**Re: Jackson Hydroelectric Project (FERC No. P-2157-188) –
Response to Deficiency and Additional Information Request**

Schedule A – Deficiency

Schedule B Additional Information Request

Attachment B

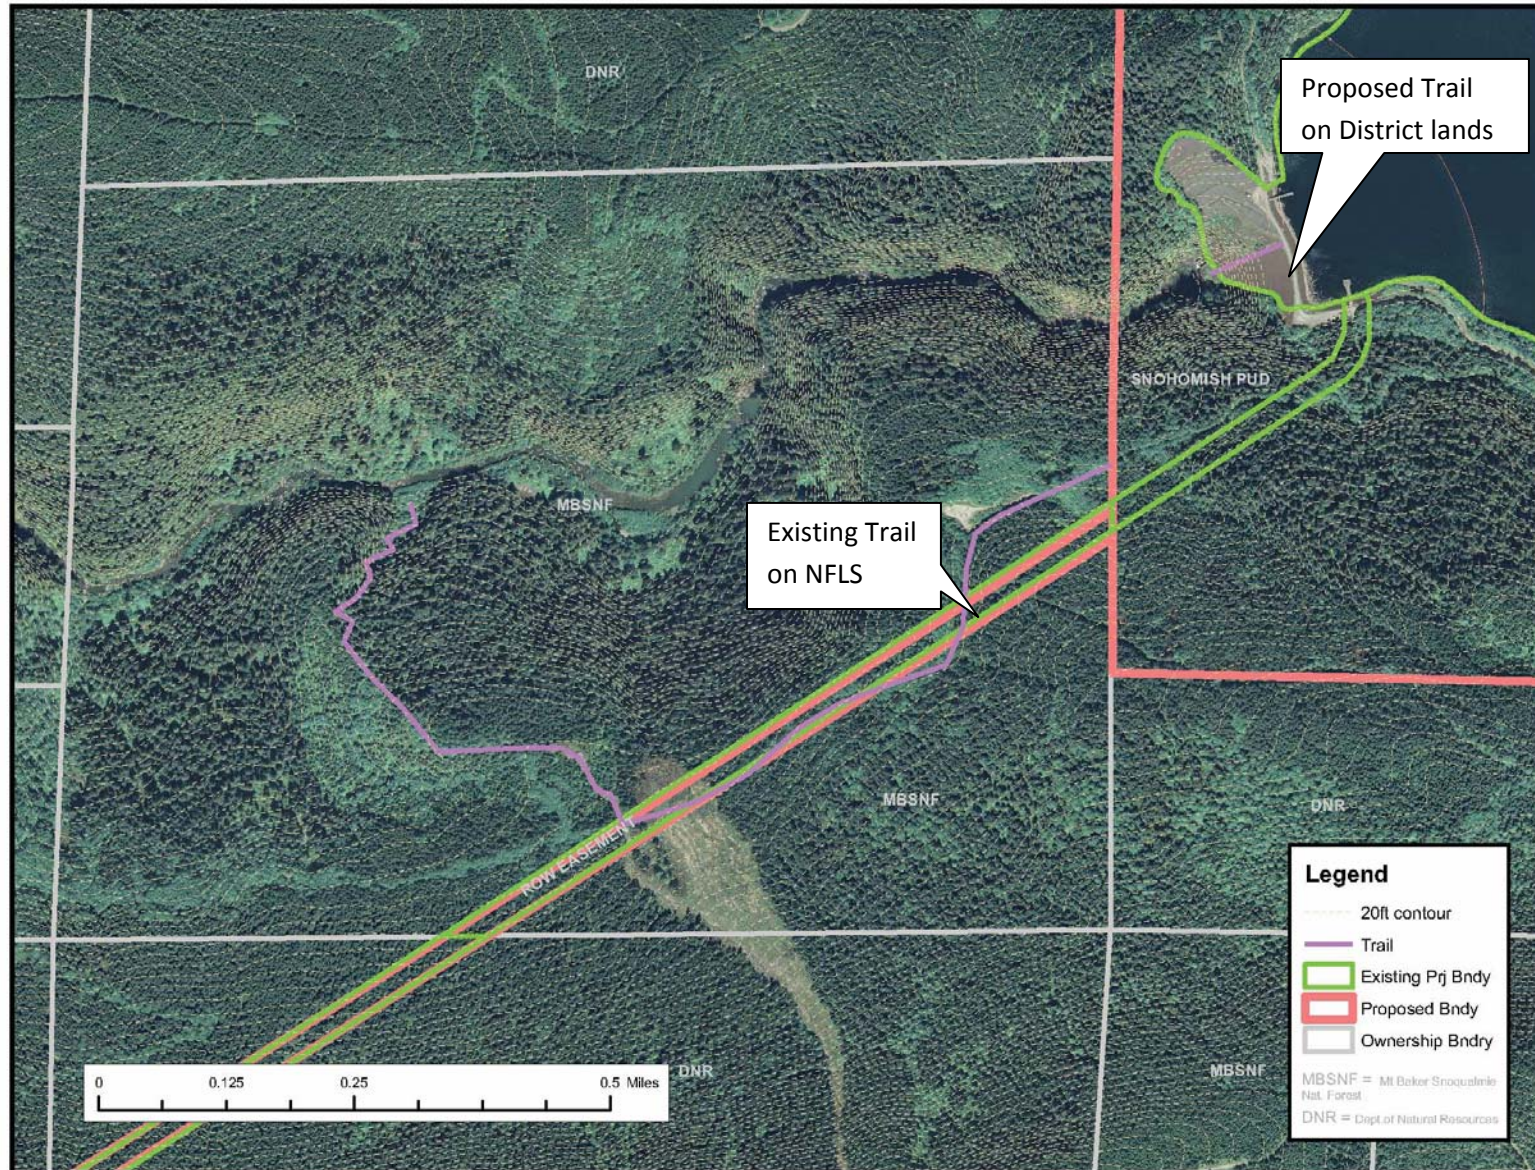
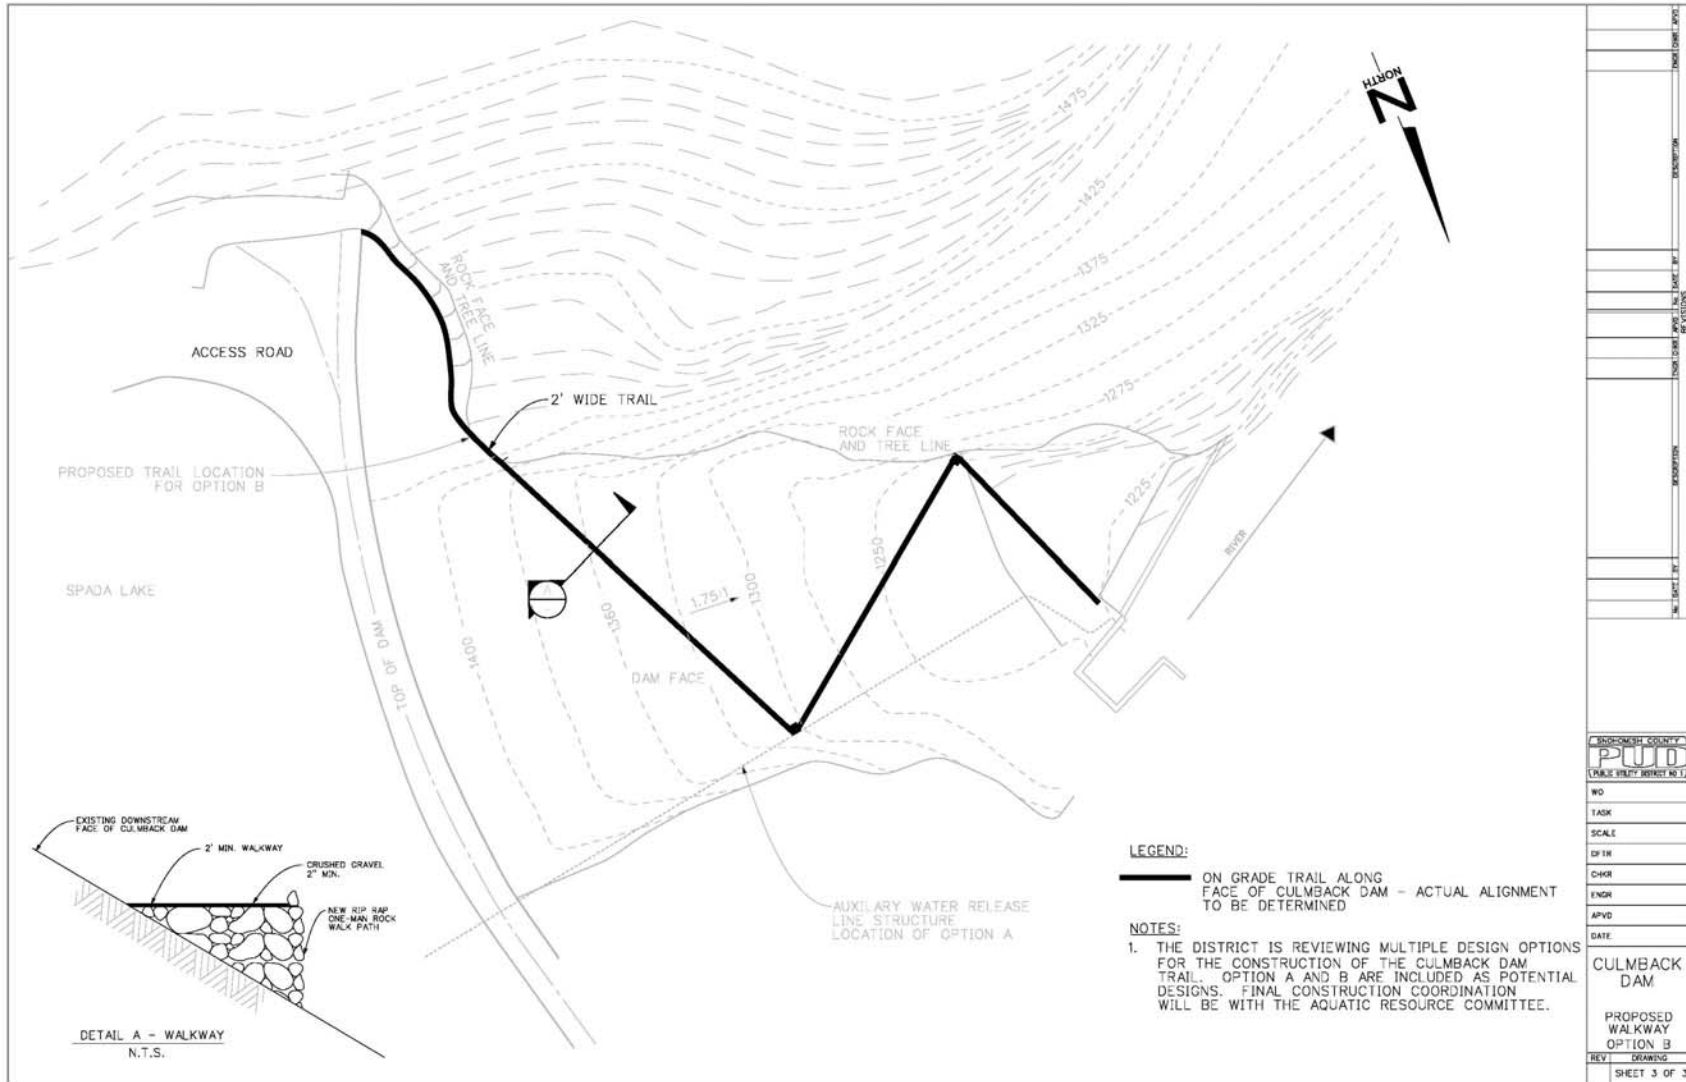
11. *On page E-347 (section E.6.7.3.1.1) of your license application, you propose to provide access to the Sultan River via a new trail down the face of Culmback dam, indicating that the trail would follow the existing release flow line and would include a grated metal catwalk with handrails. Table E.7.2-1 shows a capital cost of \$80,000 and an annual O&M cost of \$1,000 for this measure. So that we may evaluate the benefits and costs of your proposal, please provide a conceptual drawing of this new trail, including the approximate length.*

A map of the trail's location and conceptual drawings of the trail are provided as Attachment B.
